## Part B Answer

RFI Title: Framing Solution for Lavatory Wall in Typical Member Bathroom.

RFI References: drawing 1B/A9.05, Attachment #1, and Attachment #2

**PART B Answer**  
**(Attachement #1)**

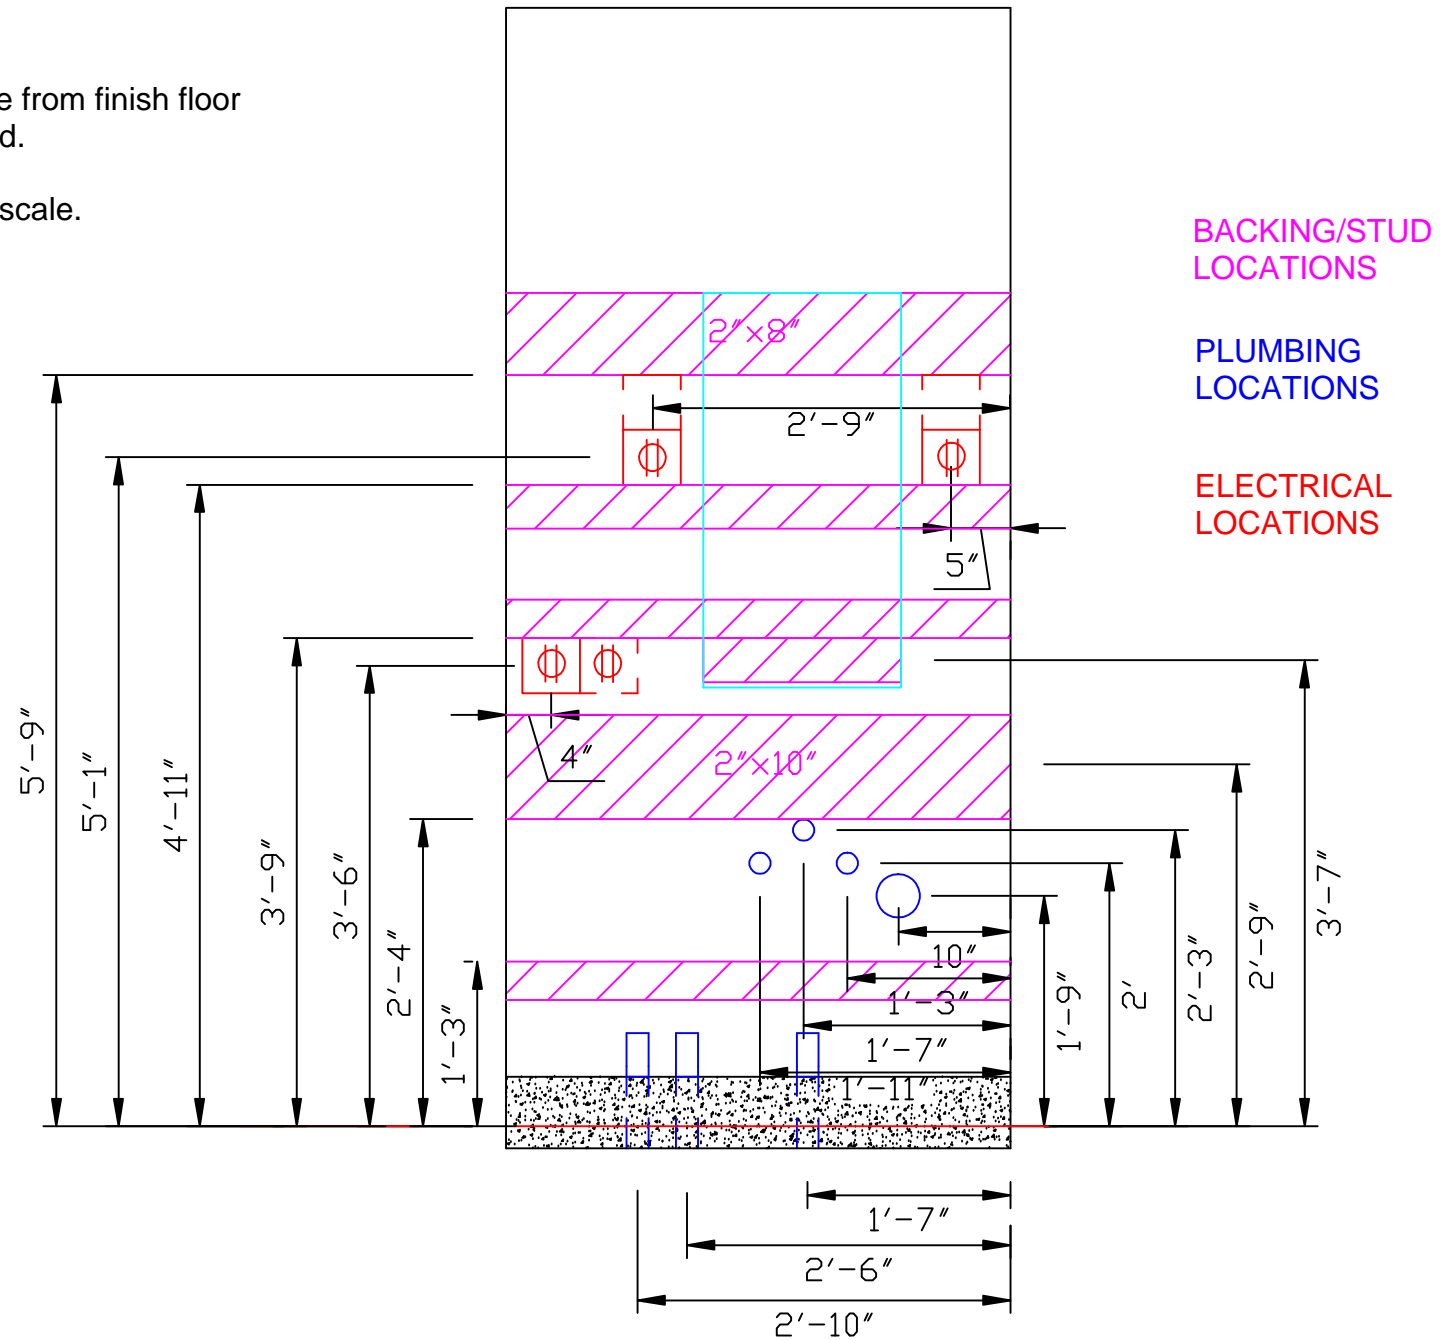
Due to the large amount of backing and the Electrical and Plumbing penetrations in the lavatory wall of a Typical Member Bathroom, the congested space does not allow for vertical studs to run up the wall. (See attachment #1) This condition exists at back-to-back lavatories (i.e. Member Toilets 1A-150T and 1A-151T) and lavatories opposite of interior walls (i.e. Member Toilet 1A-152T). To accommodate all backing requirements and without relocating the plumbing and electrical rough-in locations, Hensel Phelps proposes to frame the wall using horizontal members, in lieu of vertical members. Horizontal framing will prevent notching of studs and allow the backing and rough-in to be installed in a timely manner with quality. Please confirm the proposed horizontal framing shown in Attachment #2 is acceptable.
